UNITED STATES PATENT AND TRADEMARK OFFICE

Office Action Summary

10/622,150

COURCY, MATTHEW LOUIS

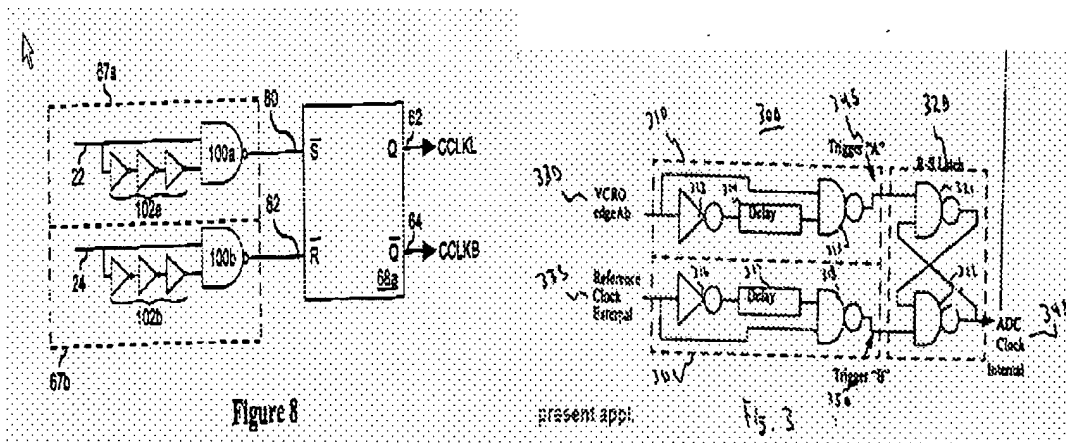
Claims 1-3, 5, 13-15 and 17 are rejected under 35 U.S.C. 102(b) as anticipated by U.S. P.A.P. 20020017936 A1 to Stark et al. Stark in figure 8 discloses: edge detectors (67a & 67b) and latch/S-R flip flop (66a).

Stark's figure 8 (on the left above) has the same configuration as figure 3 of the present application since the inverters 102a and 102b provide delay circuits. The inputs (22, 24) to the Stark edge detectors are complementary clock signals and 180 degrees out of phase. In the terms of signal period and duty cycle would be one-half clock period delayed phase.
